SUNDRY NOTICES AND REPORTS ON WELLS
Do not use this form for proposals to drill or to enter an abandoned well. Use Form 3160-3 (APD) for such proposals.

NOTICE OF INTENT TO PLUG AND ABANDON

SOUTHWEST ROYALTIES, INC.
CONTINENTAL FEDERAL #1
30-025-24110

CURRENT SALADO DRAW; DELAWARE WELL

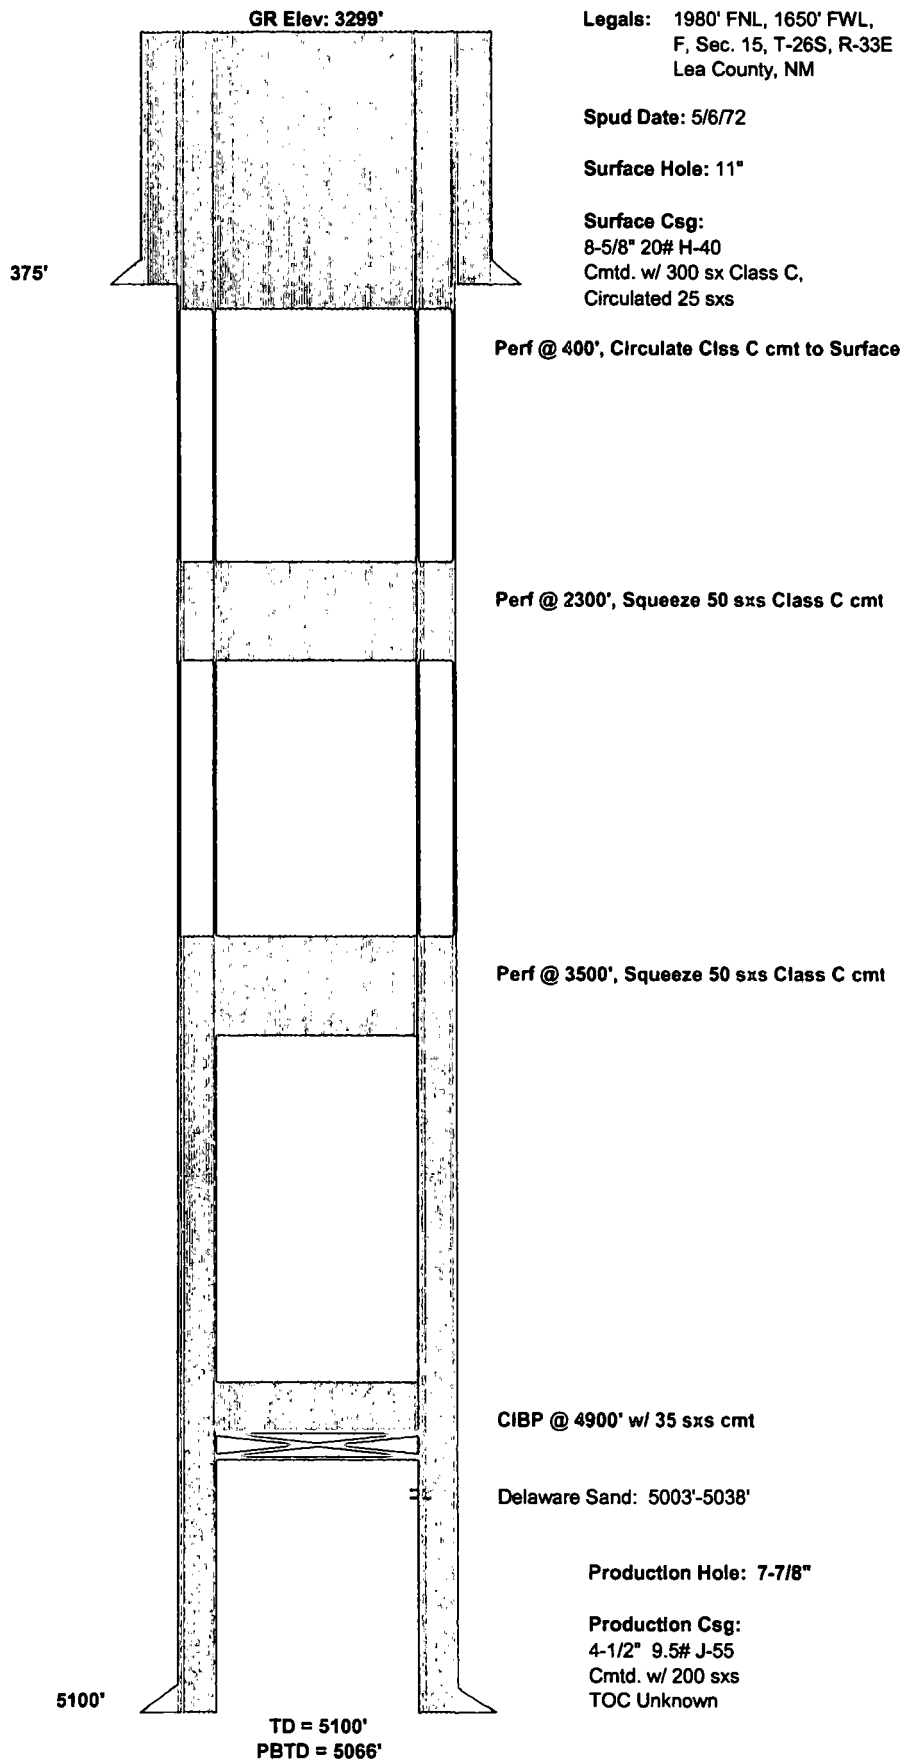
1" from 60'

T/salt 1177-4735

Del Line 4960

Del sd 4988

WOC FOR 4 HRS. TAG TOP OF CMT. 4685 (B/SALT)

PERFORATE SQUEEZE HOLES AT 3500'. SQUEEZE 50 SXS CLASS C CMT. WOC FOR 4 HRS. TAG CMT. 140' min

PERFORATE AT 2300'. SQUEEZE 50 SXS CLASS C CMT. WOC FOR 4 HRS. TAG CMT. 120' min

PERFORATE AT 400'. CIRCULATE CLASS C CMT TO SURFACE. 425 - 0'

Below ground level dry hole marker required
